Staff Report & Recommendation

Design Review Board

SUBJECT: DRB20-0585 (DRB20-0555, DRB19-0445)
420 South Hibiscus Drive

An application has been filed requesting exterior design modifications to a previously issued Design Review Approval, specifically for the changes to the site plan and exterior elevations.

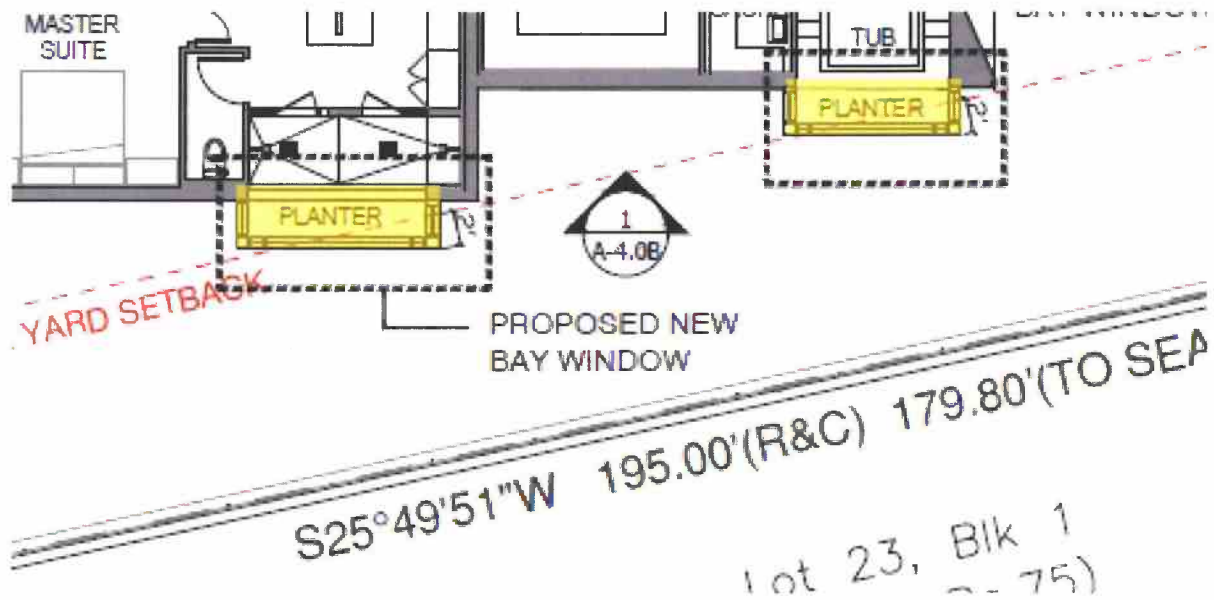
Staff also has a concern with the impact of the proposal on the previously approved waiver for the open space requirement along the south side elevation, where the bay windows are proposed. The Board approval of this waiver was fundamentally based on the site plan that provided significant movement of the two-story massing along the side elevations. The proposed new bay windows increase the second-floor massing without offsetting the second-floor design waiver previously approved, as portions of the elevation, though in the form of a window box, are proposed to encroach closer towards the side property line.

The design plans feature a zagged, serrated layout that does not create a sheer vertical wall abutting the neighboring two-story residences. The Code requires that the additional open space be regular in shape, open to the sky from grade, and at least eight feet in depth, as measured perpendicular from the minimum required side setback line. Since the projecting bay windows further decrease the "open space" from the ground "open to the sky", in those portions outside of the required side yard the previously approved waiver would need to be modified.

Detail of second floor bay windows

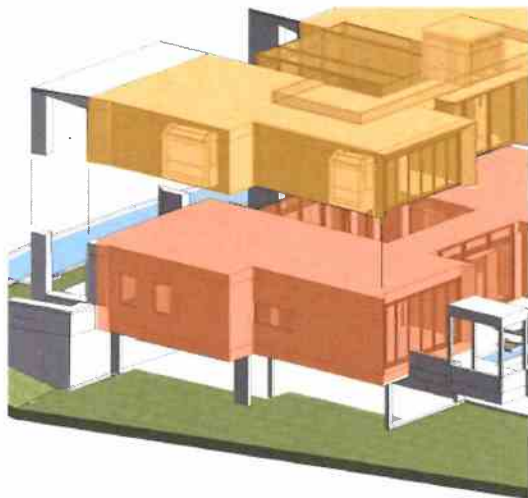
The second-floor slab of the home is configured at 29.5' NGVD. The neighboring affected property is an older home built in 1927 with a more recent addition constructed in 2007. Due to the nature of the original construction, the neighboring house sits considerably lower below the design on the contemporary structure. The proposed bay windows also reduce the amount of air and light in the setback between the properties and again, require the open space waiver to be re-assessed.

Finally, the proposed modification also increases both the perceived mass and footprint. At earlier hearings, members of the Board indicated that the proposed home appears significantly larger than the permitted allowance of square footage (due to the incorporation of the understory and the configuration of an “elevated garden” beneath which does not count towards lot coverage).

In summary, although the proposed bay windows are allowable encroachments within the side yards, they do have a significant impact on the design of the structure. In this regard, staff would suggest that the previously approved window configuration be retained, or that the proposed bay window configuration be further studied. In view of the

- a. The proposed windows within both of the projecting bay windows of the bathroom elements (showers and tubs) along the south elevation at the second level shall not be approved as proposed, in a manner to be reviewed

- a. The proposed windows within both of the projecting bay windows of the bathroom elements (showers and tubs) along the south elevation at the second level shall be an opaque or frosted glass element to ensure minimal

gaze into the abutting property in an effort to preserve the privacy of the abutting property, in a manner to be reviewed and approved by staff consistent with the Design Review Criteria and/or the directions from the Board.
